Proposed Temporary Private Vehicle Park for a Period of 3 Years and Filling of Land in “Village Type Development” Zone, Lot 741 (Part) in D.D. 111, Pat Heung, Yuen Long, N.T.

Responses to Comments for Drainage Services Department

申請編號：A/TL-PH/1069

Plan of Catchment Areas

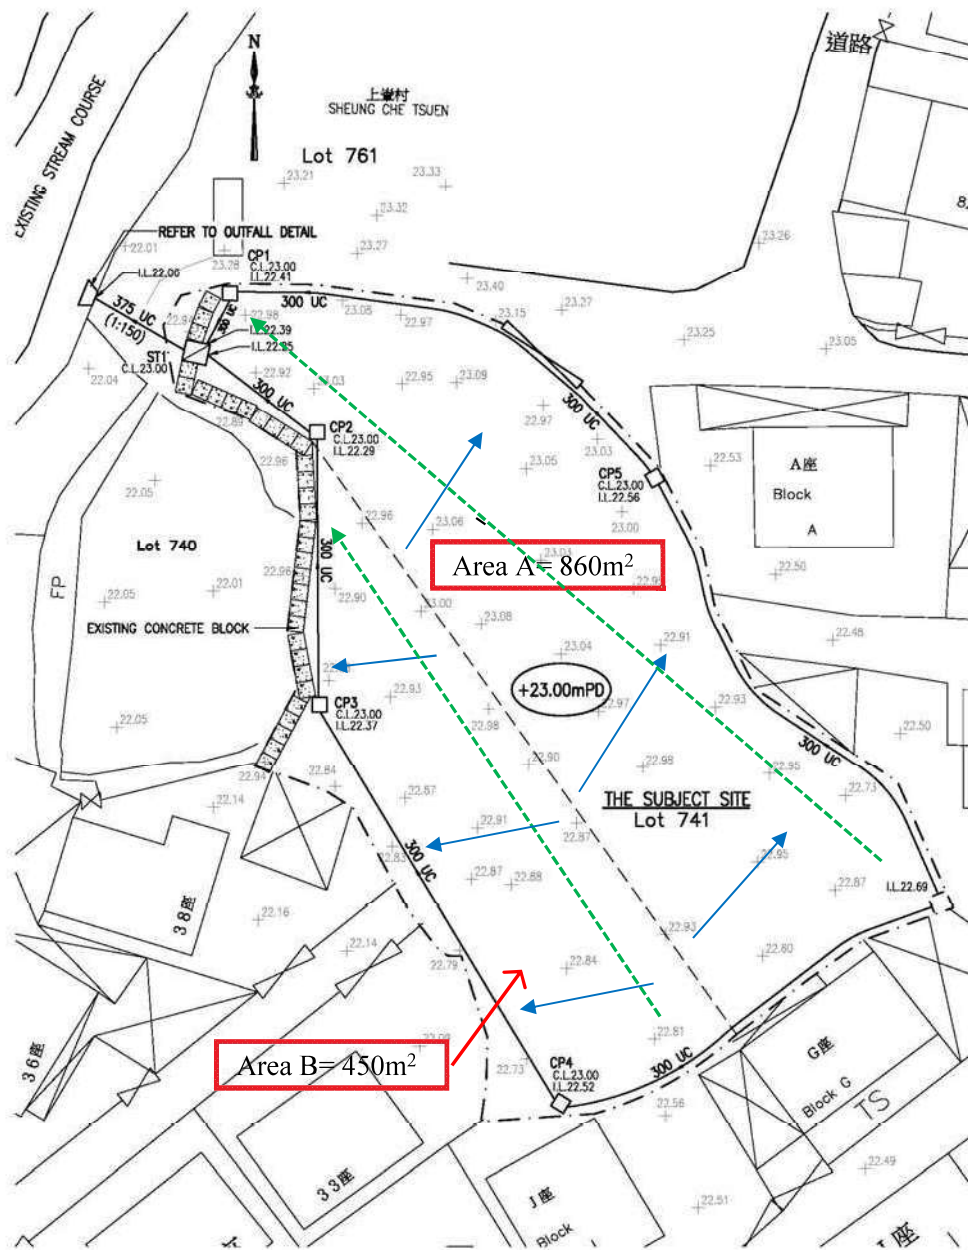
| (b) 300 UC with gradient of 1:200 are proposed by the applicant. Please demonstrate with hydraulic calculation that the proposed drainage facilities are adequate to collect, convey and discharge the surface runoff accrued on the application site and to the overland flow intercepted from the adjacent lands. Please also indicate the gradient of the proposed 375 UC and showing its C.L. and I.L. at outfall detail. | See attachment |

3. Checking requirement width by rainwater through between CP5 to ST1

a. Catchment Area A to Proposed Drainage (300 UC)

Therefore, used 300mm UC is adequate for catchment area of A.

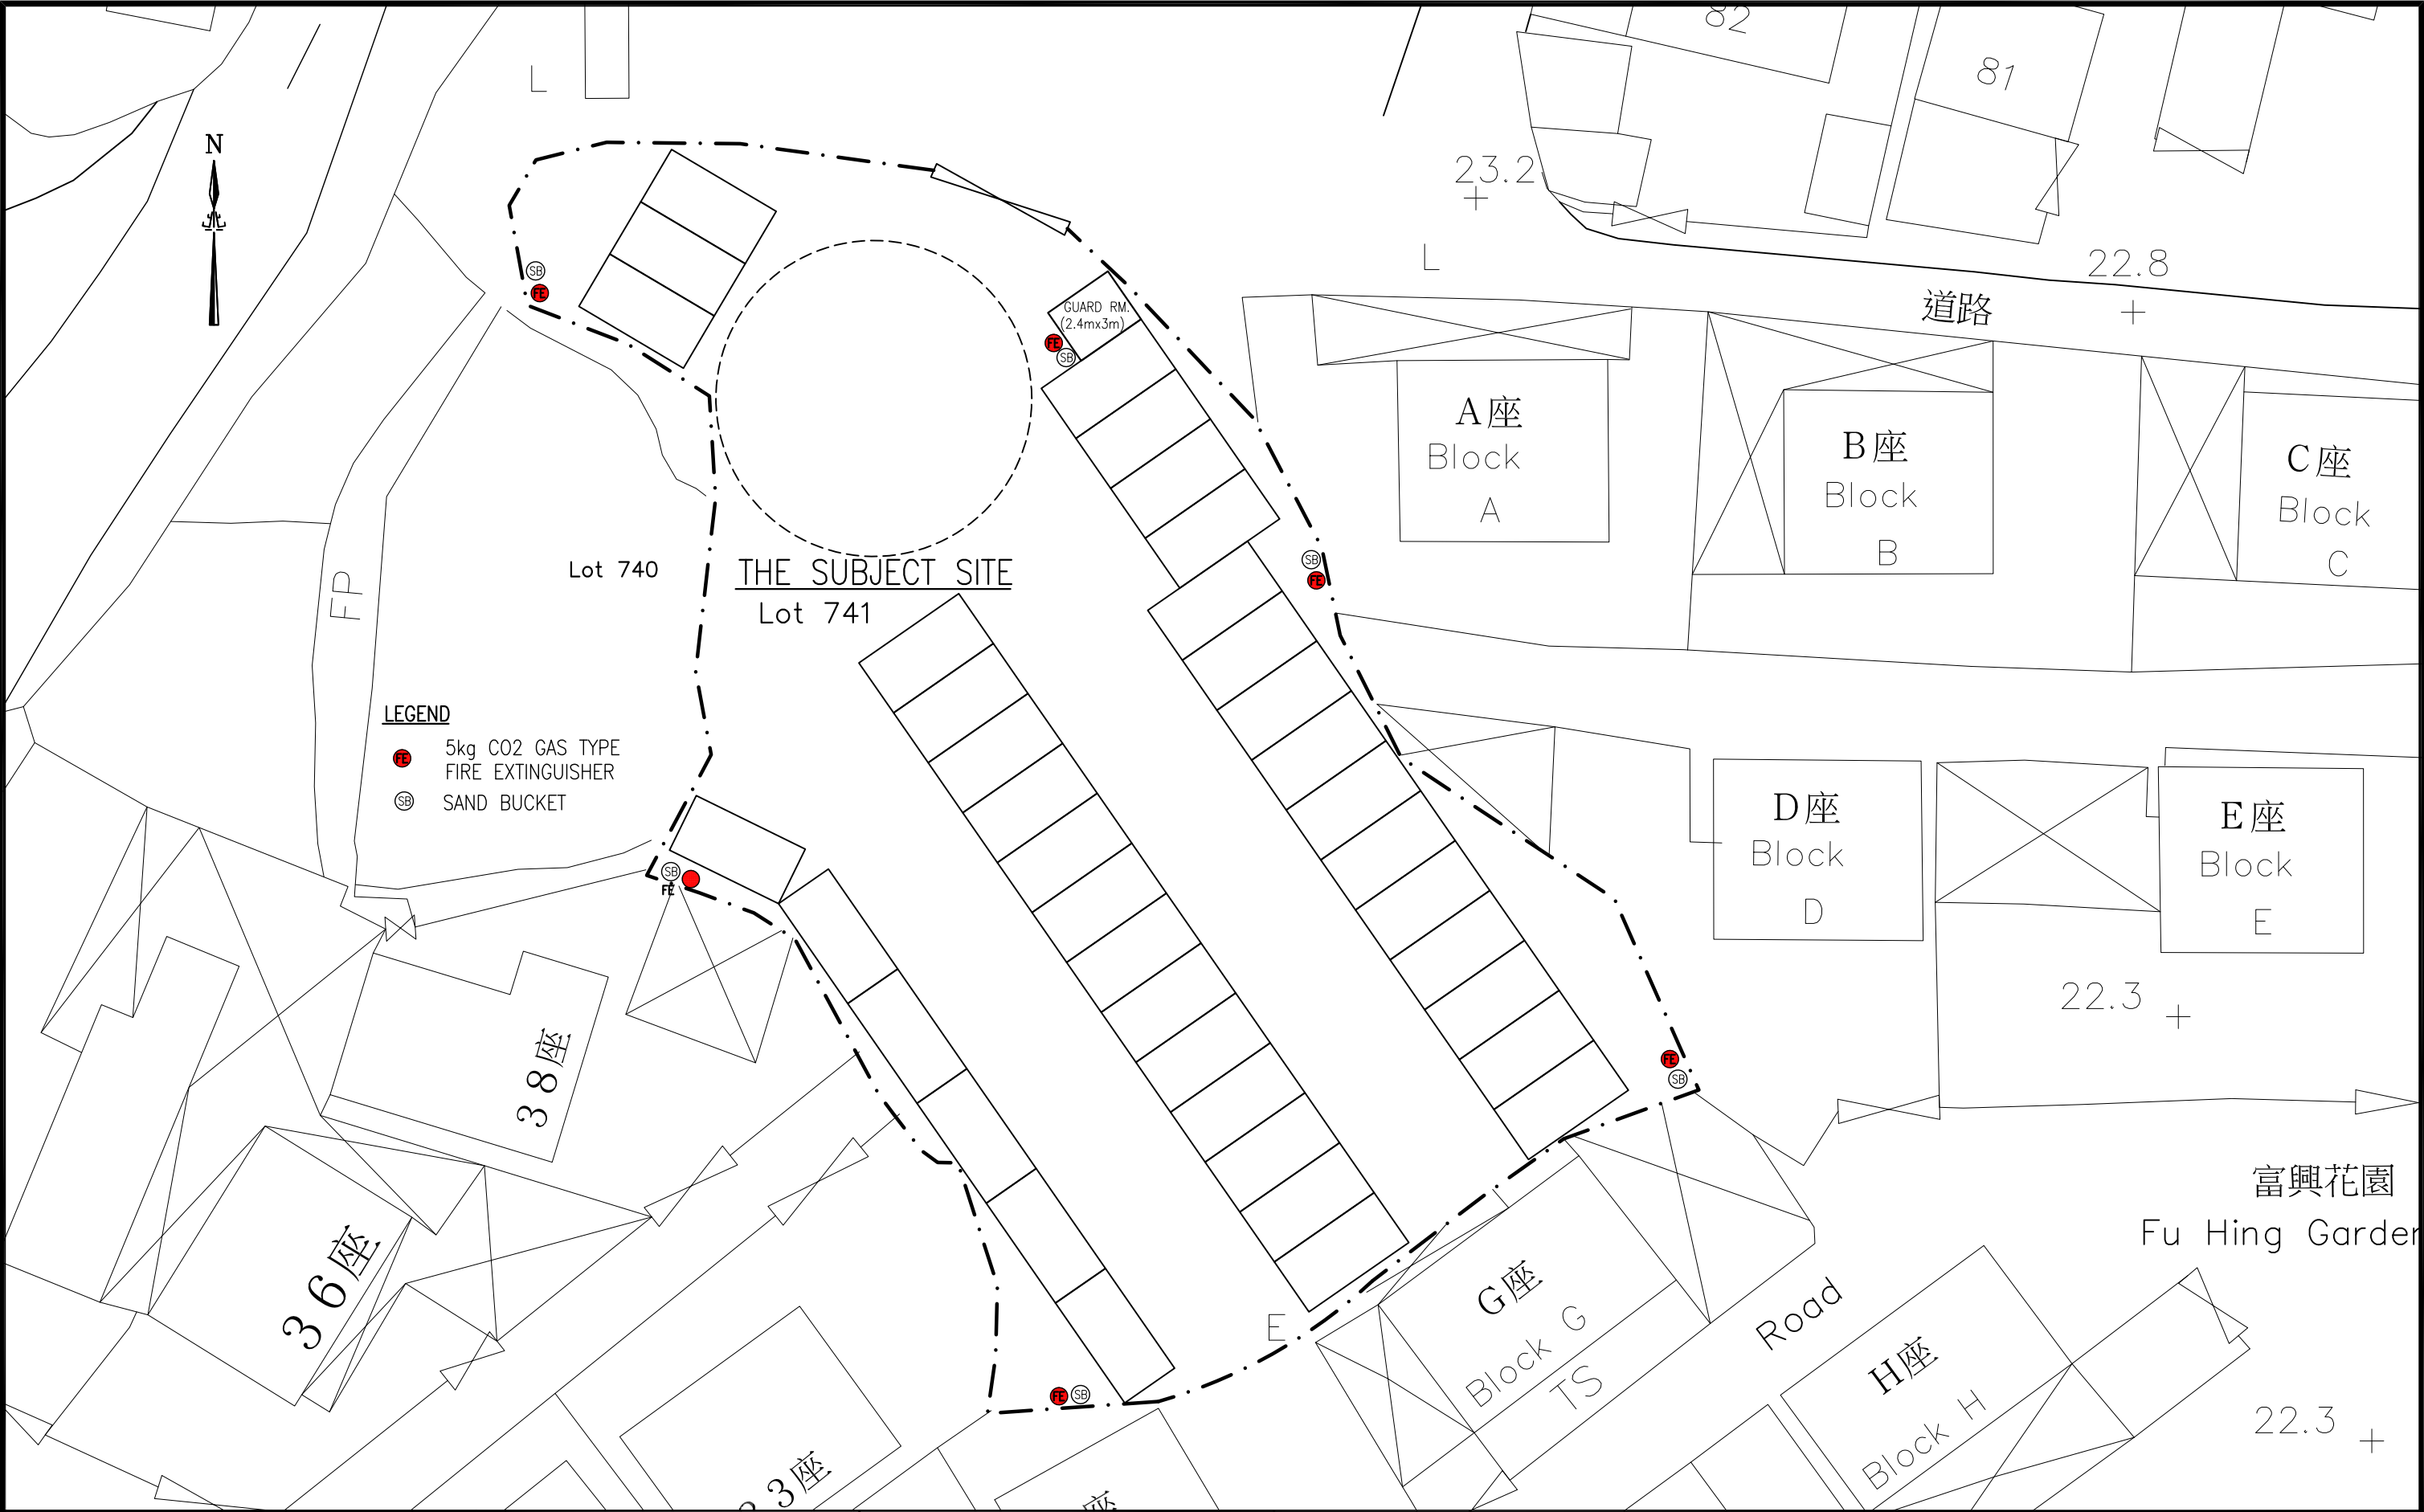
| (c) Cross sections showing the existing and proposed ground levels of the captioned site with respect to the adjacent areas should be given. | See attachment |
| (d) The proposed finished G.L. of the subject site is 22.3 which is about 0.6m higher than the existing G.L. of 21.7. Please demonstrate the proposed site formation works will not affect the overland flow from the adjacent lands. | See attachment |

This discrepancy in the site formation level and the raised filling depth can be attributed to the irregular topography of the application site, where the existing level does not correspond to the actual elevation of the surrounding areas. Consequently, the site formation level has been adjusted to +23 mPD, which exceeds the approved filling depth of 0.5m (from +21.7 mPD to +22.2 mPD).

We acknowledge this difference and was submitted the revised actual site level of drainage proposal on 4th November 2024, including a detailed of site sport levels which was prepared by land surveyor for supporting, to address the raised site formation level and comply with the necessary approvals. We will ensure that all actions are in line with the requirements of the approval conditions and seek further clarification or approval as required.

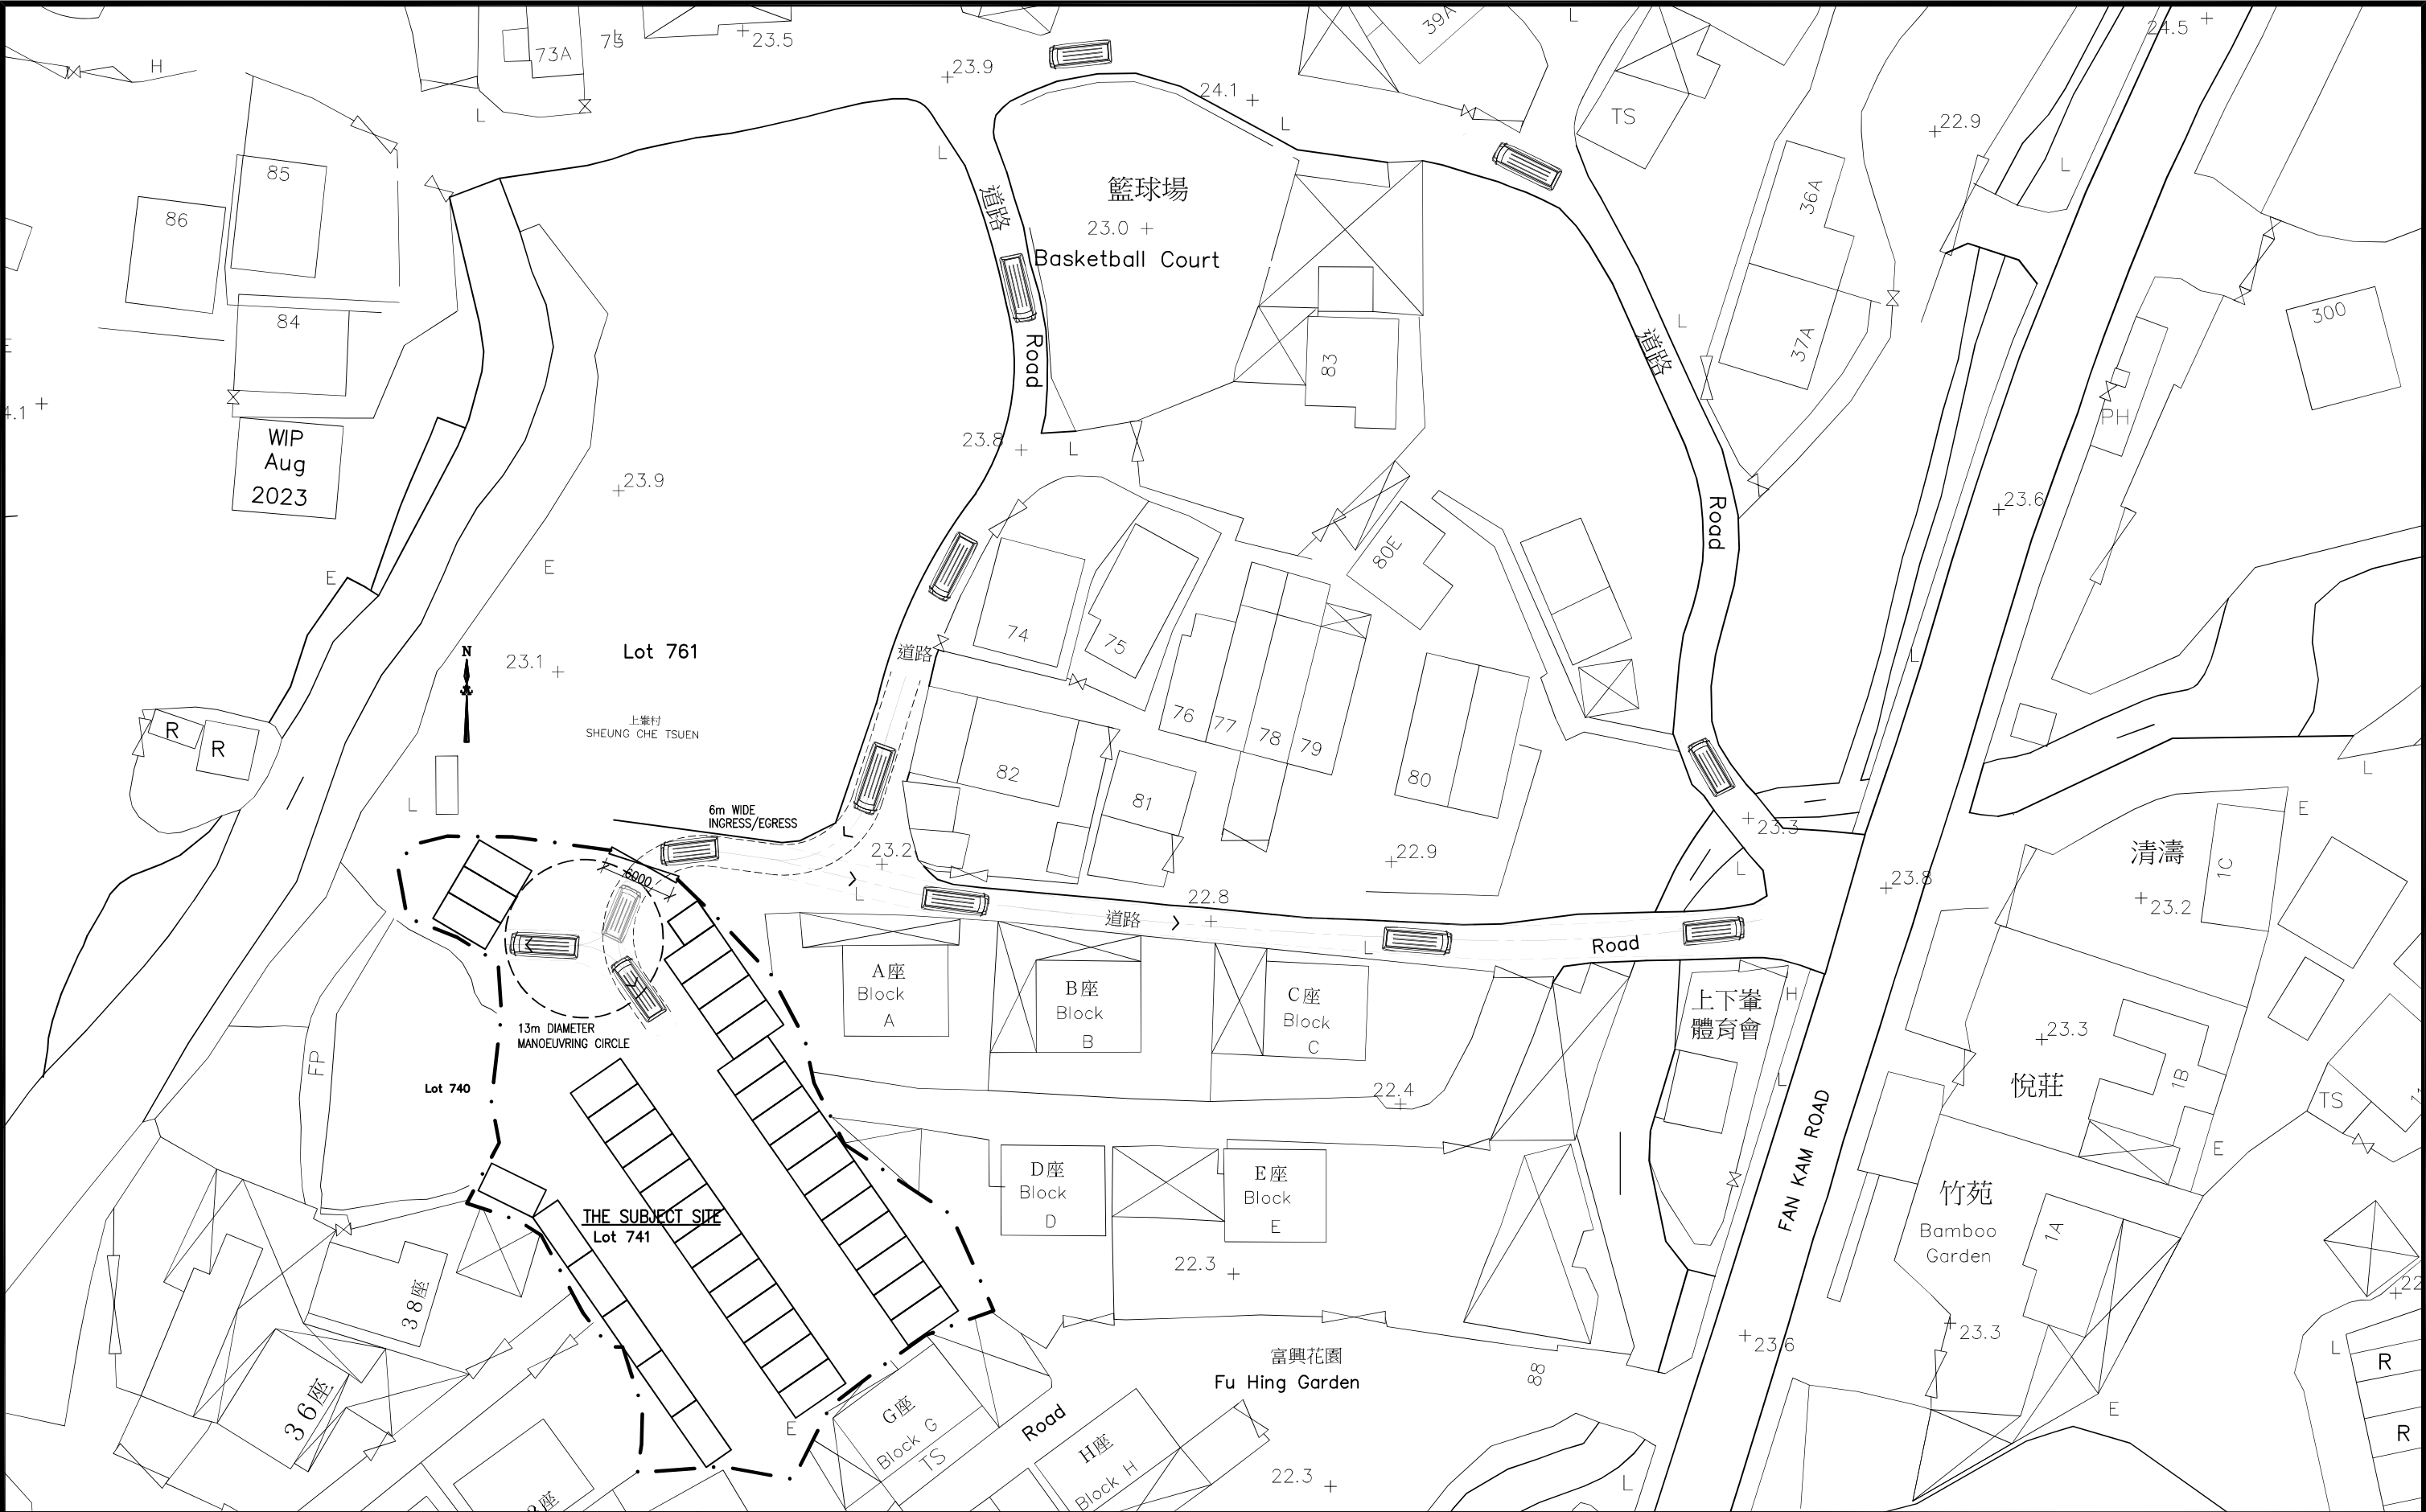
回應運輸署：

現附上一張擬議行車路徑圖。申請這個停車場不會對入村的道路做成太大的影響，由粉錦公路轉入路經一條現有的車路可直達申請場地，場內有足夠空間給車輛轉彎掉頭，由場內右轉出來轉再左轉可以行另一條道路轉出粉錦公路，因為有兩條路可以進出，對現有的道路不會做成阻塞。由粉錦公路轉入申請場地是經過一條現有入村必經的私人道路，這條道路不是運輸署所管轄的路段。
